SUBJECT: Responds to NRC 800221 letter re fire protection program.
 Discusses insulation of pipes, portable extinguishers, lube
 oil shielding sys, electrical cable penetrations & fire door
 supervision.

H. B. ROBINSON STEAM ELECTRIC PLANT UNIT NO. 2
DOCKET NO. 50-261
LICENSE NO. DPR-23
FIRE PROTECTION PROGRAM

Attached please find Carolina Power & Light Company's (CP&L) response to your letter of February 21, 1980 concerning fire protection at H. B. Robinson Unit No. 2.

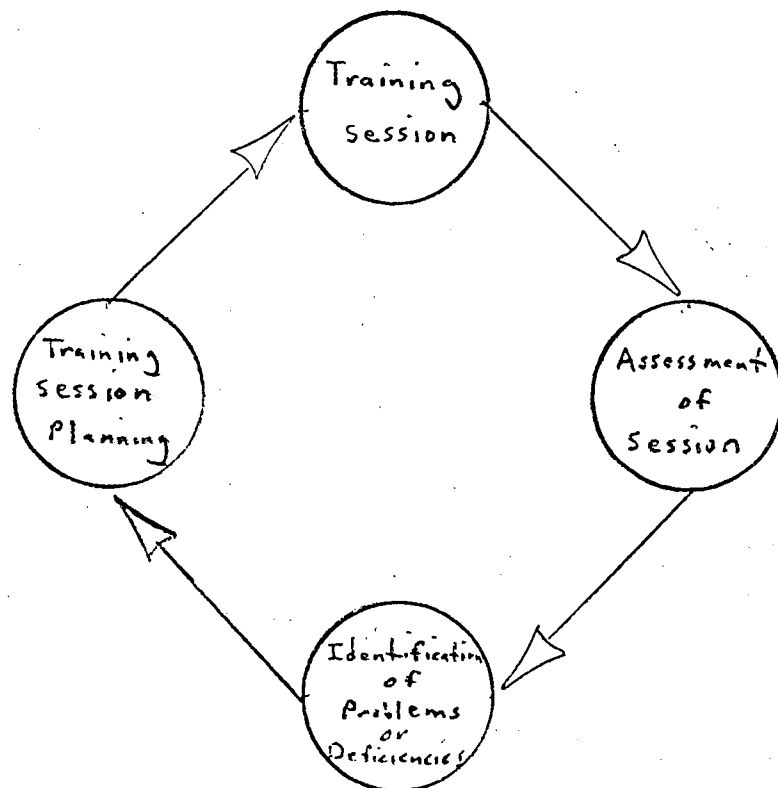
- (a) The key to an effective fire brigade is effective training. Such training must consist of two elements - classroom training and field training (practice in a controlled situation). The proper balance between these two types of training as well as the

adequacy of each type training must be assessed periodically. The results of this assessment is then fed back into the training program so that the program may be modified as needed to establish the desired proficiency. This technique will produce a training program which is tailored to meet the needs of the brigade. Additionally, this technique will provide a program which is flexible enough to accommodate the changing needs of the brigade that occur due to change in personnel, changes in equipment, and improvements in fire fighting tactics and strategy. This approach to training is illustrated below:
